## Informal meeting on Code of Practice for Packing of Cargo Transport Units

#### Updates to the CTU Code

## Bulk transport

### Submitted by ETS Consulting

**Figure 25 – Pattern of stowage and fastening of a liner with goods**

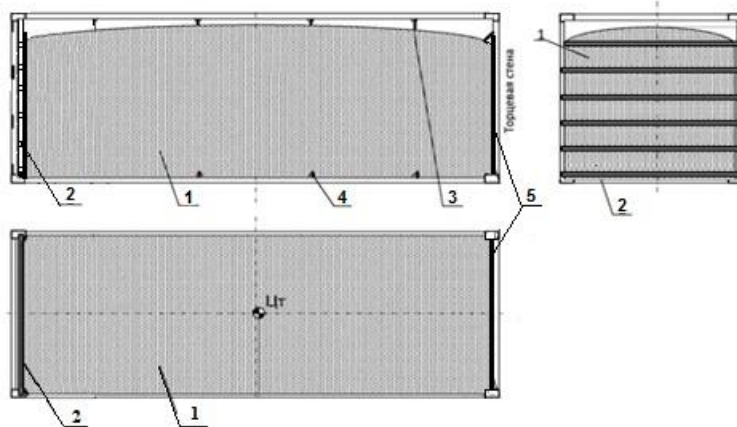
Loading shall be performed in a smooth flowing manner in the container floor space (Figure 25). The maximum loading height shall not exceed the level by 100 mm lower than the upper edge of the doorway opening safeguard or end wall of a container.
